SUBJECT: NEW VEHICLE DEMONSTRATION / DELIVERY HOLD - Safety Recall 18S10
Certain 2018 Model Year Expedition, F-150, F-650 and F-750 Vehicles
Transmission Selector Lever Cable Inspection

CERTAIN 2018 MODEL YEAR EXPEDITION, F-150, F-650 AND F-750 VEHICLES — TRANSMISSION SELECTOR LEVER CABLE INSPECTION

FIGURE 2

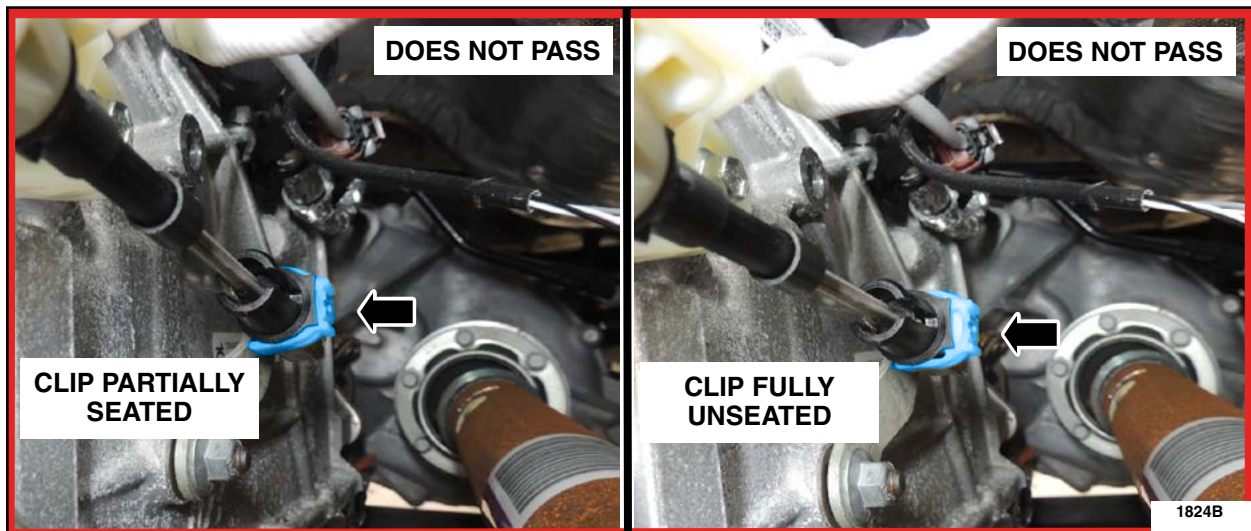
4. Inspect the selector lever cable adjuster lock to ensure it is fully seated. See Figures 2 and 3.
- If the cable adjuster lock is fully seated as shown in Figure 2, proceed to Step 5.
 - If the cable adjuster lock is not fully seated as shown in Figure 3, proceed to Step 6.
